OET Requested Information

FCC ID : **ANO20020302R1L**
 Applicant : **International Business Machines Corporation**
 Correspondence Reference Number: **230207RC.ANO**
 Confirmation Number : **TC3010**
 Original Requested Date : **February 07, 2003**

Plots of the antenna gain (left antenna)

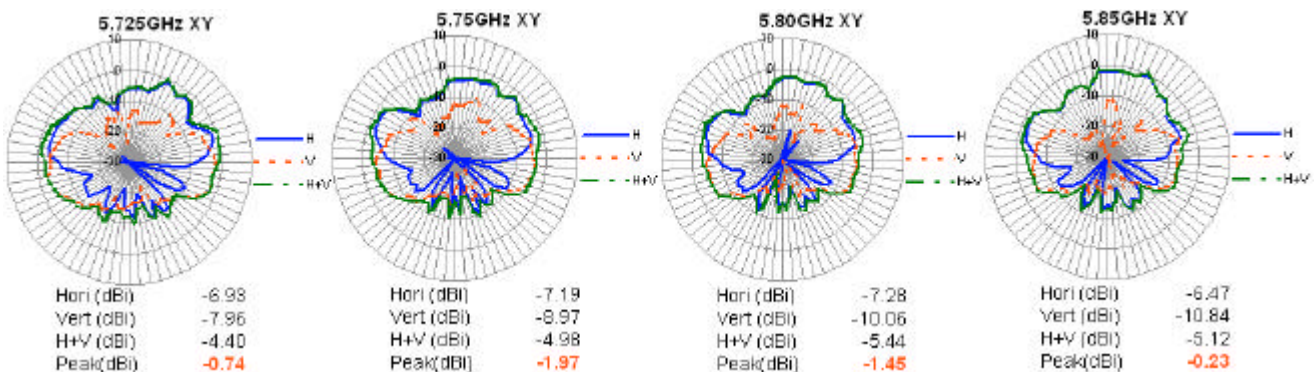
Subject 3) Please clarify the RF Exposure (MPE) exhibit shown on the Power Table page 7/8 (5.725 - 5.85 GHz) which shows operational frequencies outside the requested frequency band of operation. Please confirm.

Answer 3) The operation band for the applying transmitter is 5.745 – 5.825GHz, but the measurement was performed with the full allocated frequency band of DTS devices (i.e. 5725M-5850MHz). The plots below show the peak antenna gains for the **main (left)** antenna. The gains at the both band-edge frequencies are higher than the operation band's gain. So the peak gain of the operation band never exceeds –0.23 dBi for the main antenna.
